**Building Exterior:**

**Roof and HV/AC Equipment:**

**Building Interior:**

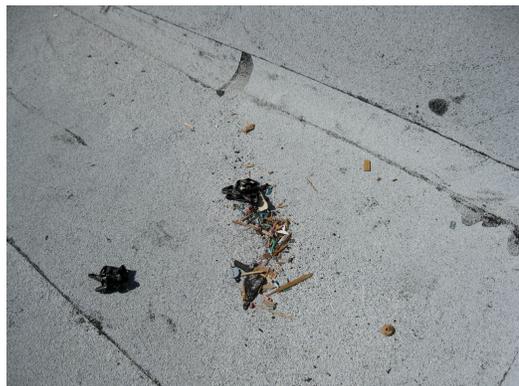
- a. The roof hatch hasn't been painted and has hot roofing tar all over it. **(See Photo #8, hereon).**
- b. There is a split in the mineral cap sheet at the south west outside corner atop the parapet wall adjacent to the roof hatch. Needs mastic sealer. **(See Photo #9, hereon).**
- c. There is an excessive amount of extra roofing granules that have washed to the low areas and scuppers of the roof and should be swept up and removed from the roof.
- d. There is miscellaneous roof debris, i.e.- wire cuttings, electrical tape, and metal knock outs scattered throughout the roof. **(See typical Photo #10, hereon).**
